Addendum No. 1

Subject: BLANKENBURG ELEMENTARY SCHOOL
NEW CAFETERIA AND KITCHEN
SDP CONTRACT NOS. B-060 C, B-061, B-062, B-063 C OF 2020/21

Location: BLANKENBURG ELEMENTARY SCHOOL
4600 W. GIRARD AVENUE,
PHILADELPHIA, PA 19131

This Addendum, ***dated 26th of February, 2021***, shall modify and become part of the Contract Documents for the work of this project. Any items not mentioned herein, or affected by, shall be performed strictly in accordance with the original documents.

G101

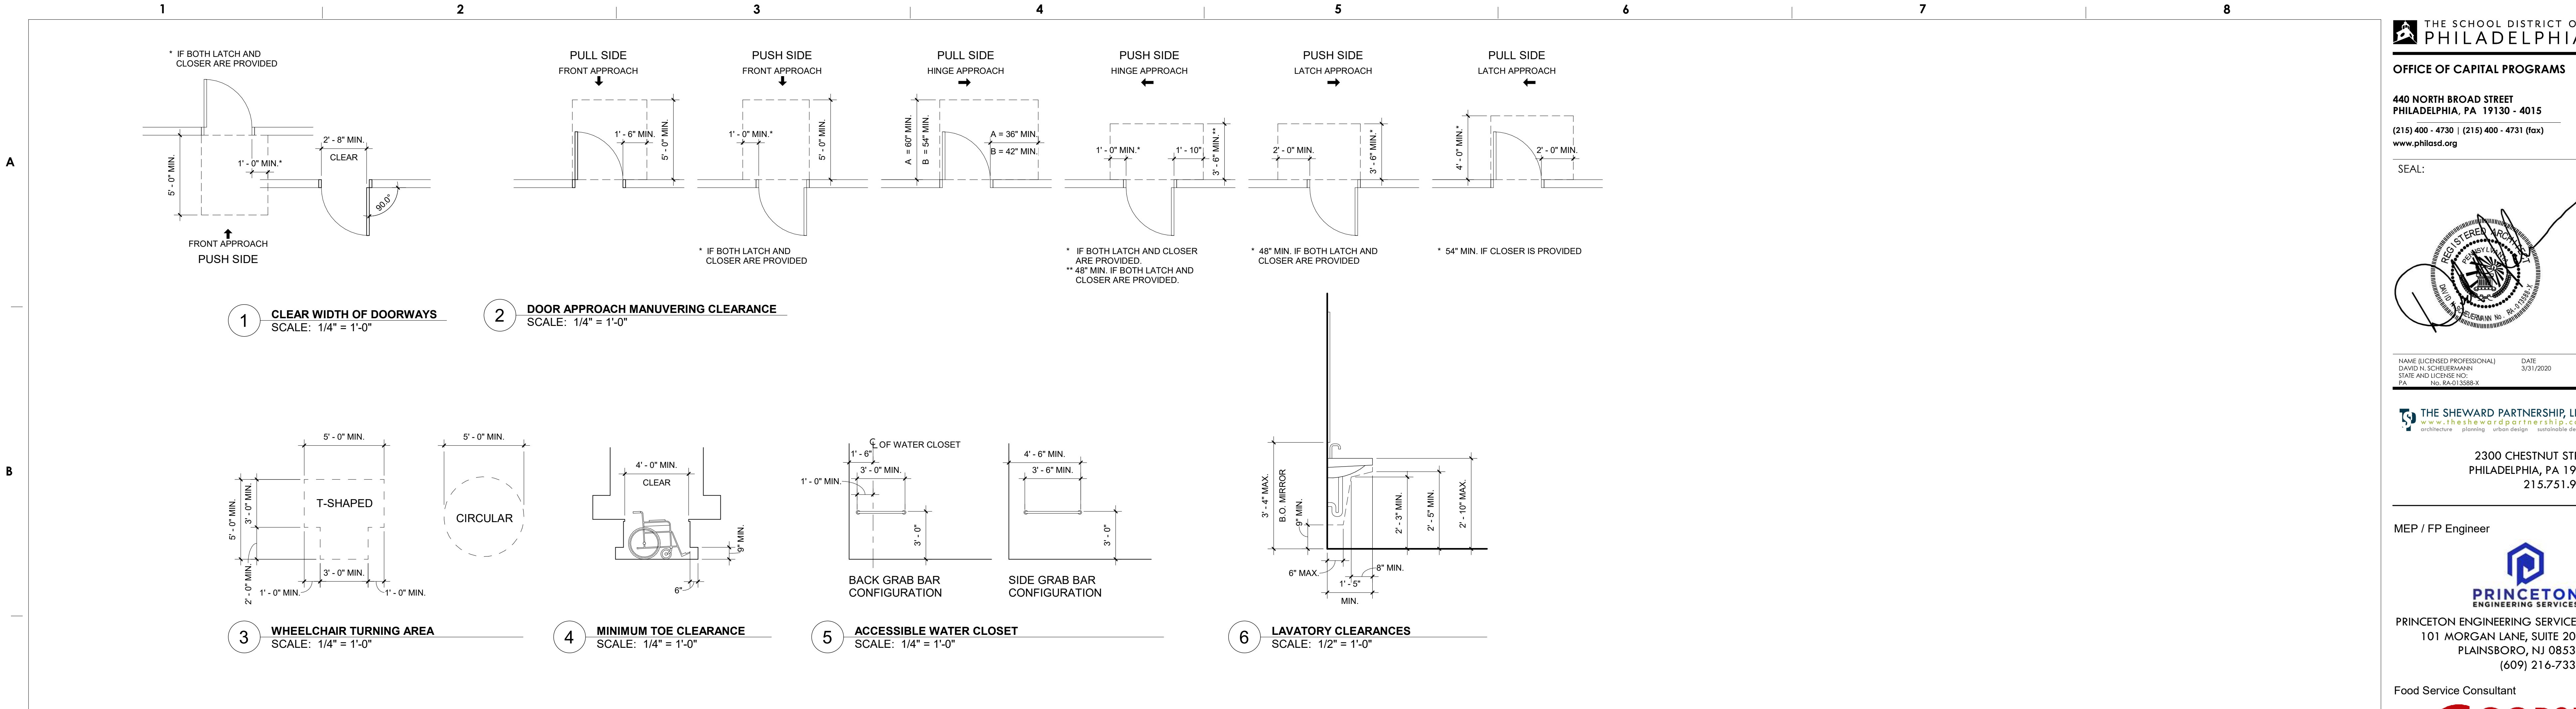
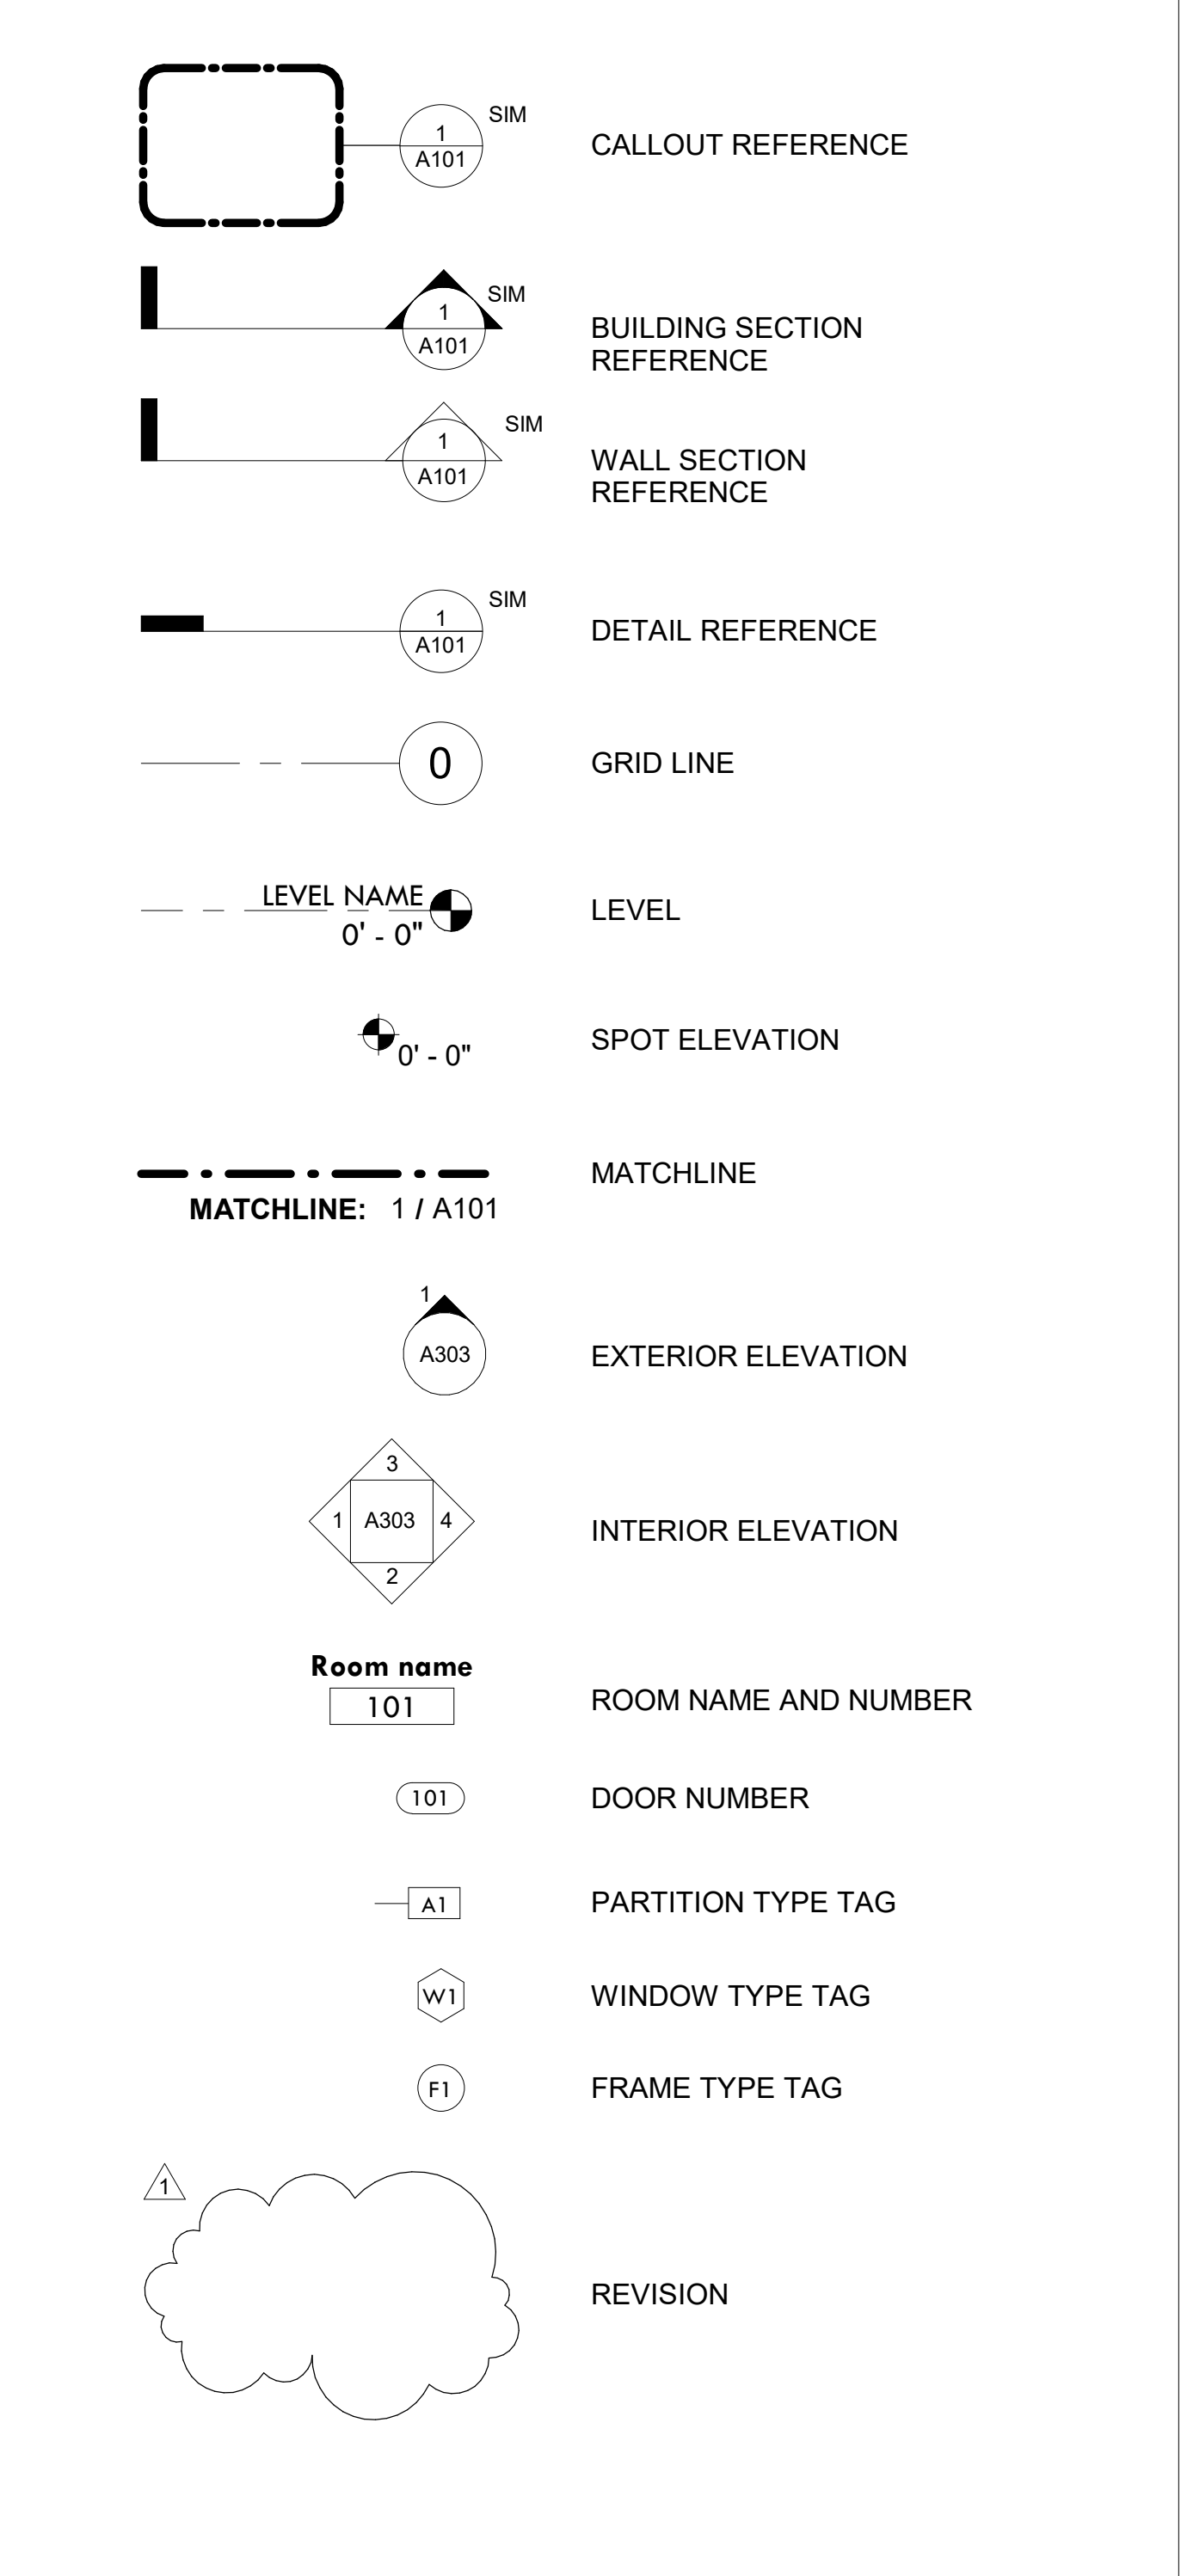
3. Deadline for questions has passed; no more new questions will be received.
4. Revised Drawing Sheets Issued
 - a. Drawing G101:
 - i. Added "COORDINATION WITH OTHER PROJECTS" notes.

- WORK IN ROOM 31 (LIBRARY / IMC) SHALL BE COMPLETED PRIOR TO COMMENCEMENT OF ANY WORK ASSOCIATED WITH KITCHEN AND CAFETERIA.
- DO NOT CLOSE IN PARTITION ASSOCIATED WITH WORK IN ROOM 31 (LIBRARY / IMC) UNTIL CONCURRENT CLASSROOM MODIFICATIONS ELECTRICAL WORK ASSOCIATED WITH THIS WALL IS COMPLETED. COORDINATE WITH CONTRACTORS ON SITE TO ENSURE CLEAR SEQUENCE OF WORK.

AD101

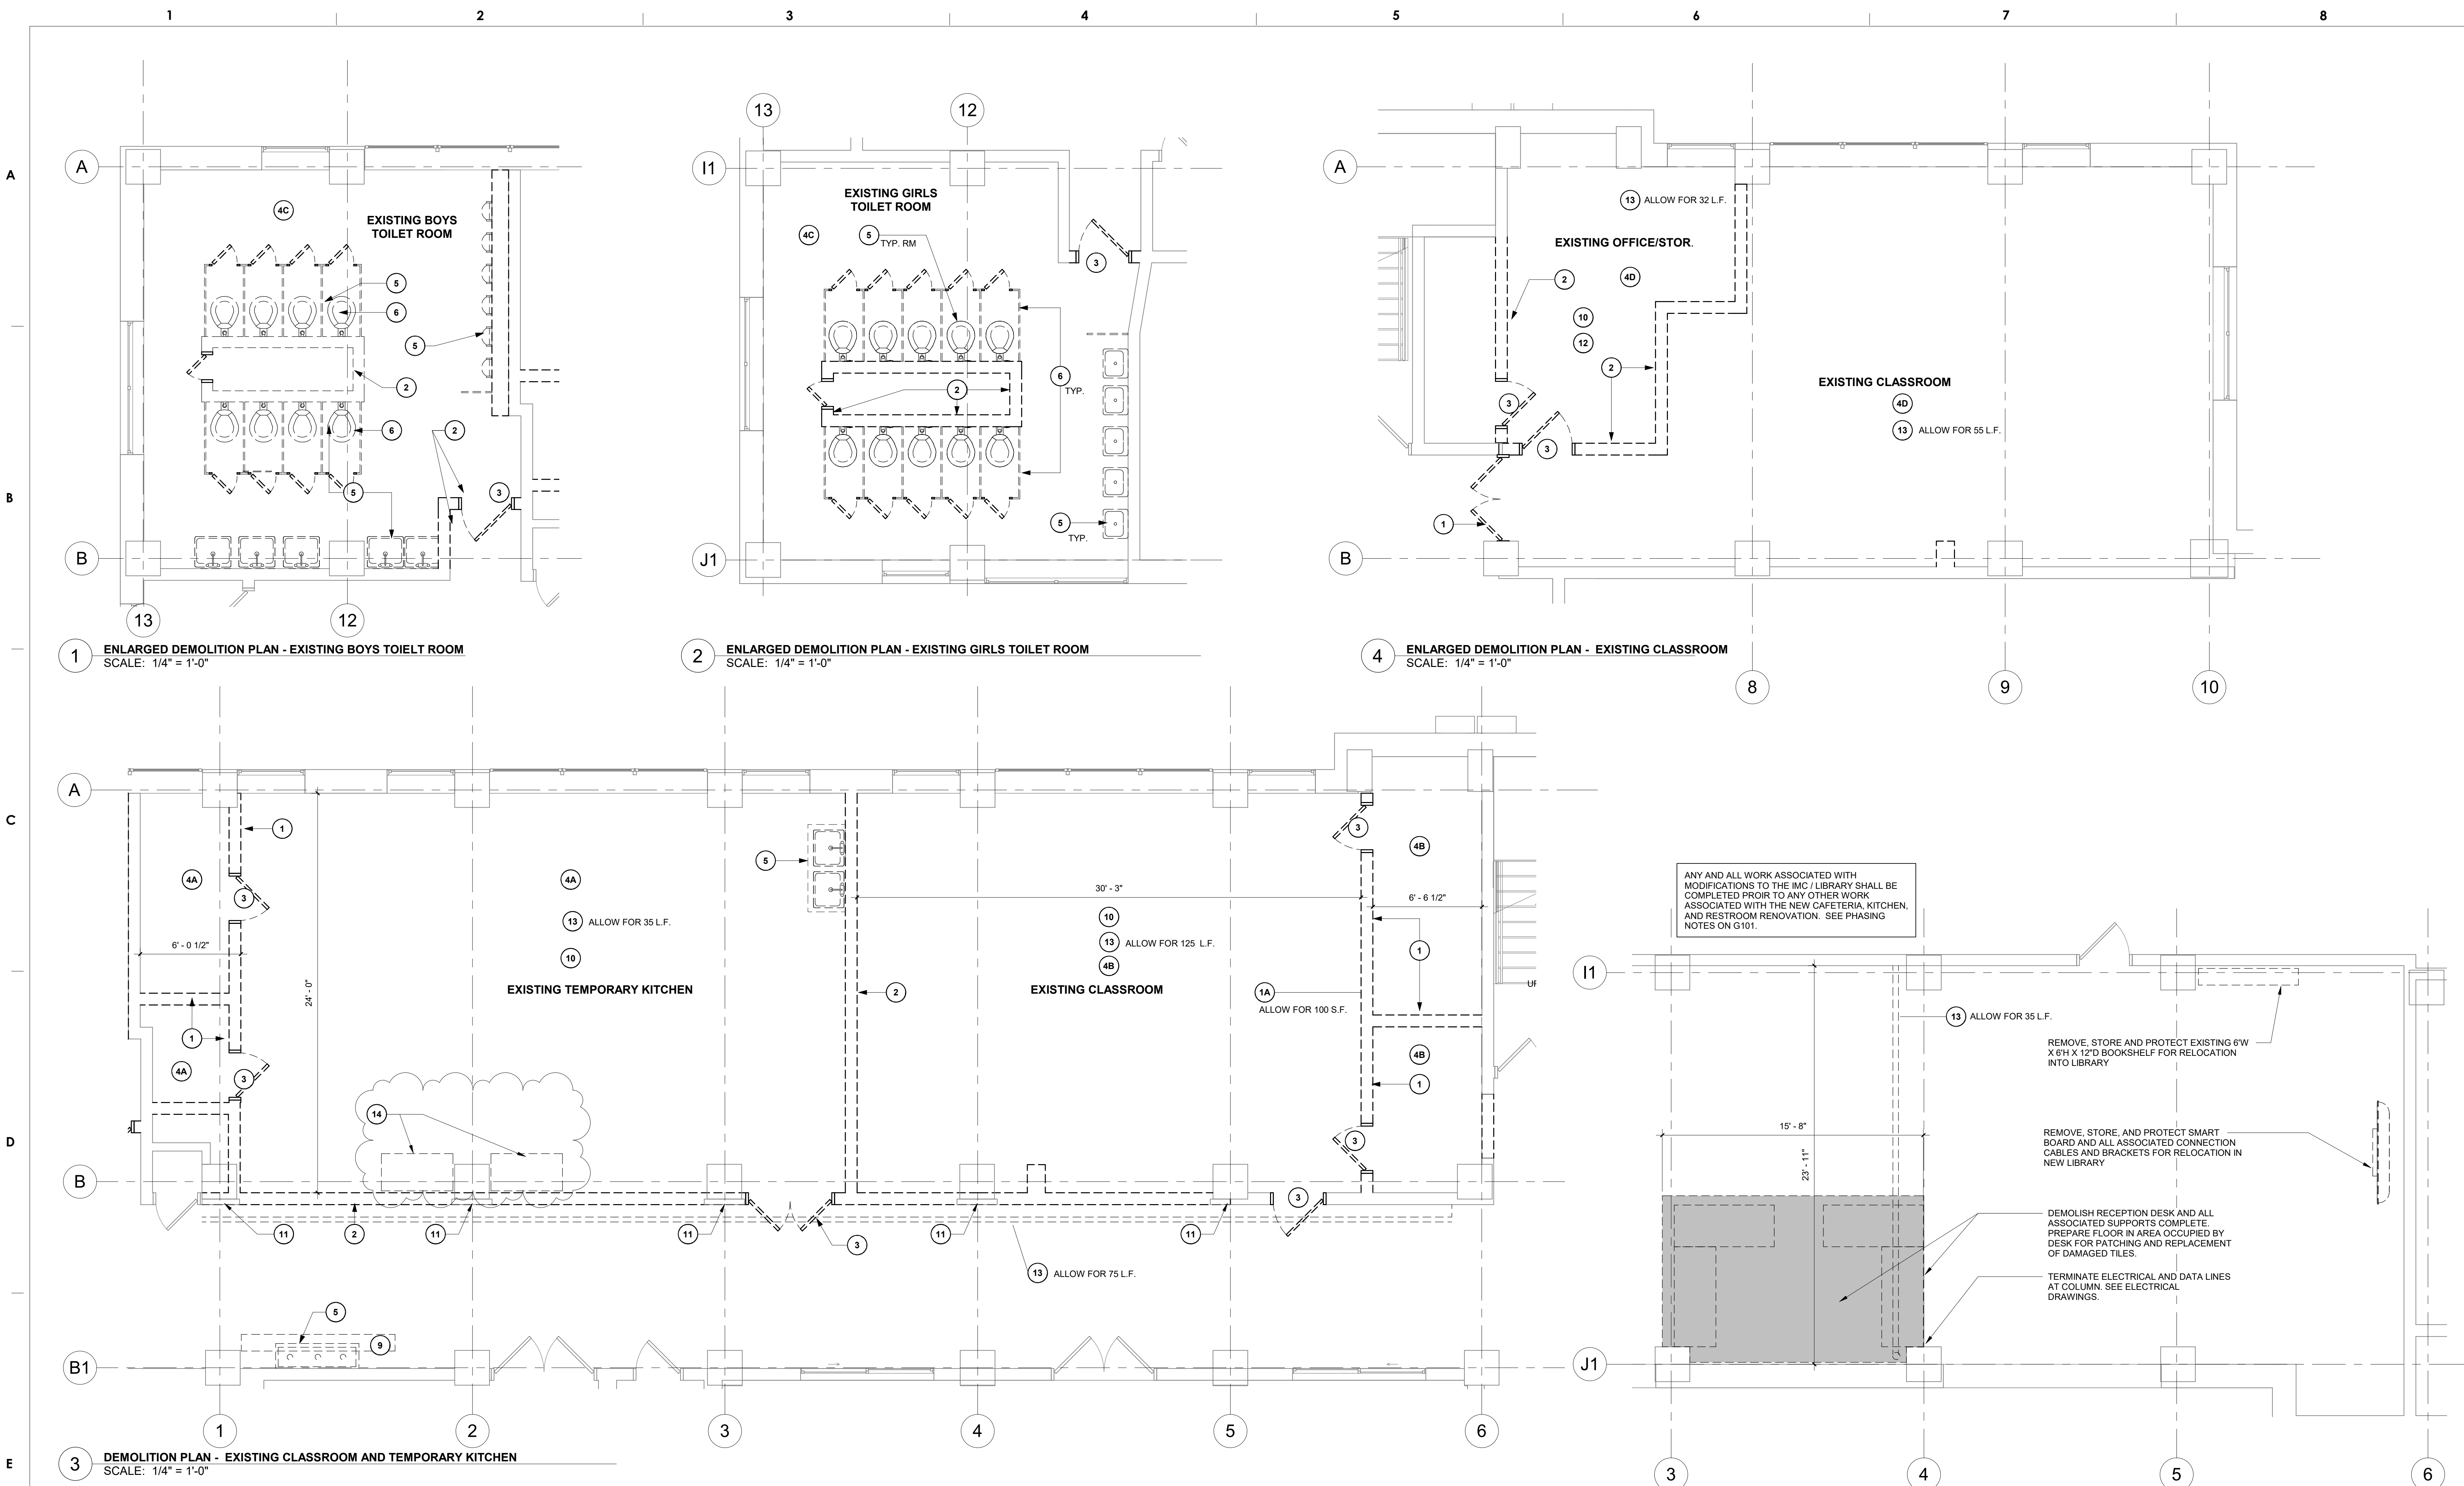
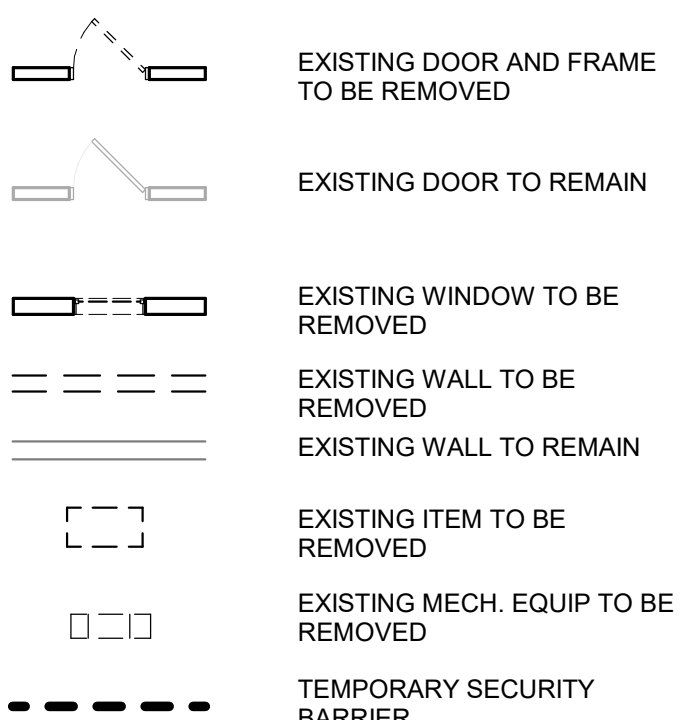
- b. Drawing AD101:
 - i. Added Keynote 14: Remove and relocate two (2) built-in existing wood storage cabinets from Existing Temporary Kitchen. Relocation in the school building to be determined.

1. See attached photo of cabinets with this addendum.
 - c. Drawing A400:
 - i. Revised notes on plan at Room 31 (library / IMC).
 - d. Drawing FA000:
 - i. Revised fire alarm drawing.

- REMOVE ACP CEILING AND SUSPENSION GRID
- REMOVE AND ABATE ACM PIPE INSULATION. ALLOW FOR PIPE LENGTHS INDICATED ON DRAWINGS.
- REMOVE AND RELOCATE TWO (2) BUILT-IN EXISTING WOOD STORAGE CABINETS FROM EXISTING TEMPORARY KITCHEN. RELOCATION IN THE SCHOOL BUILDING TO BE DETERMINED.
